**ADDENDUM No. 2**

**Sealed Bid # 12-5658**

**Mountain View Aquatic Center Air Quality Improvements and Interior Renovations  
Cobb County Parks, Recreation and Cultural Affairs Department**

**DATE: APRIL 4, 2012**

MSK-4

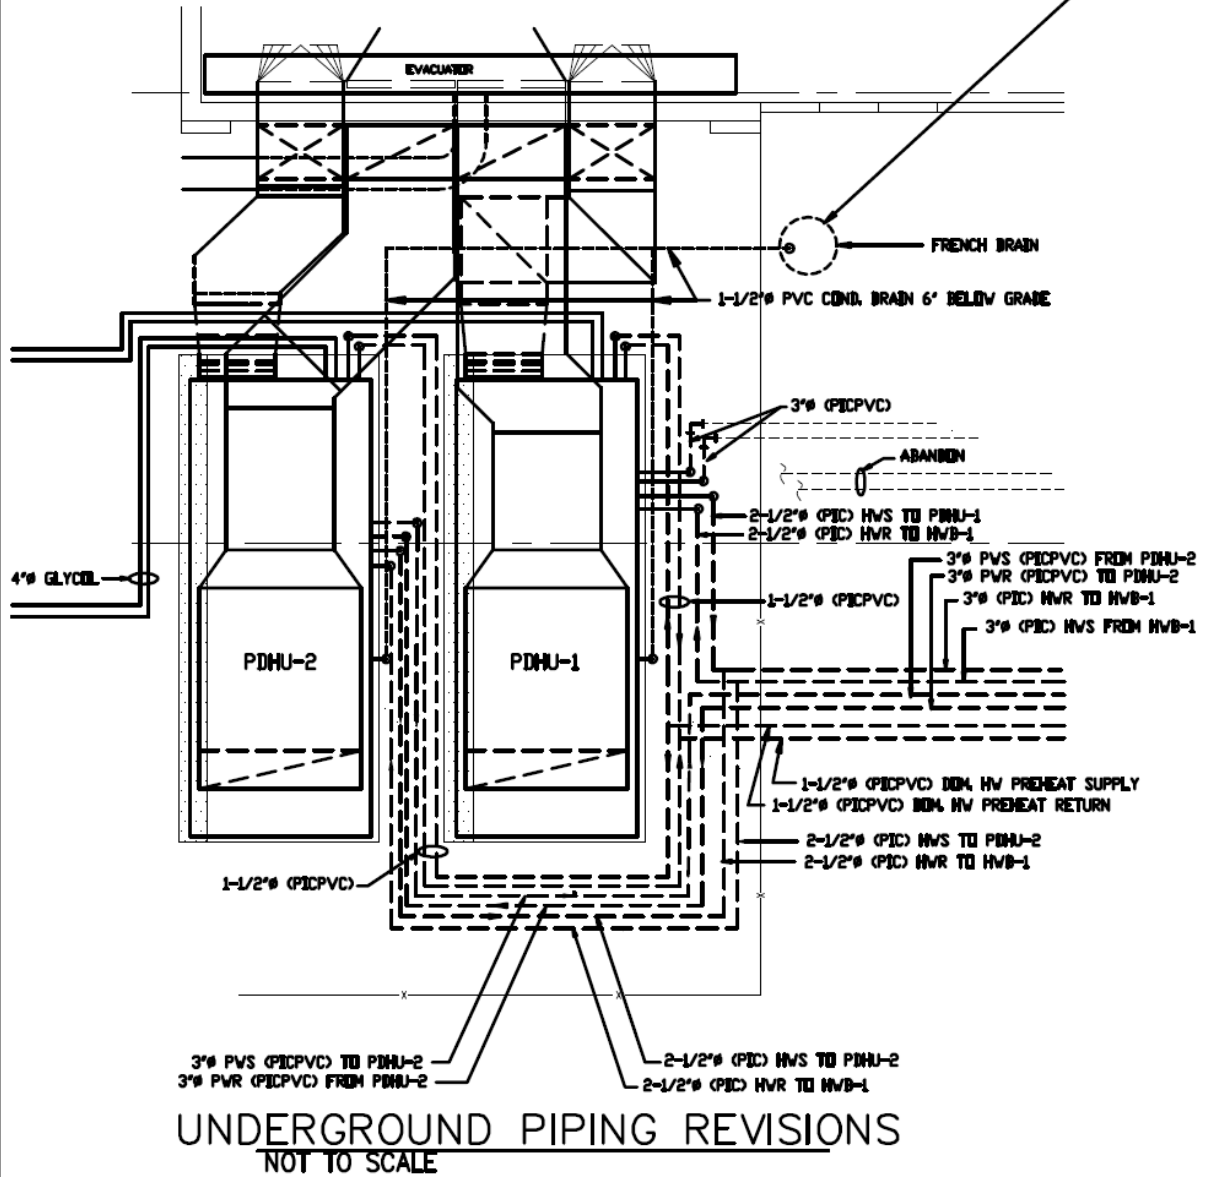
1. Refer to drawing M-2. The underground piping associated with PDHU-1 and PDHU-2 shall be revised per the attached sketch MSK-4 titled UNDERGROUND PIPING REVISIONS.

2. Refer to drawing M-2. Paved areas removed to accommodate piping and the existing hole outside the roll up door (previously excavated for the purpose of pipe repair) shall be filled with suitable soil backfill and 4" of 3000 psi concrete over 4" of compacted graded aggregate base (GAB). Soil backfill material under the GAB shall be compacted to 98% of the maximum density determined by ASTM D698 in 6" lifts by hand operated (hand tamp) equipment. No heavy equipment or rollers will be allowed. Contractor shall take special precautions to ensure pipe is not damaged by backfill operations. Place and compact initial backfill of subbase material, free of particles larger than 1 inch in any dimension, to a height of 12 inches over the utility pipe or conduit. Carefully compact initial backfill under pipe haunches and compact evenly up on both sides and along the full length of utility piping or conduit to avoid damage or displacement of piping or conduit.

FRENCH DRAIN SHALL CONSISTS OF A PIT 36' X 36' X 24' DEEP FILLED WITH COURSE GRAVEL. THE DRAIN PIPE SHALL EXTEND INTO THE PIT NOT LESS THAN 6 INCHES BELOW GRADE AND SHALL BE SECURELY ANCHORED IN PLACE.
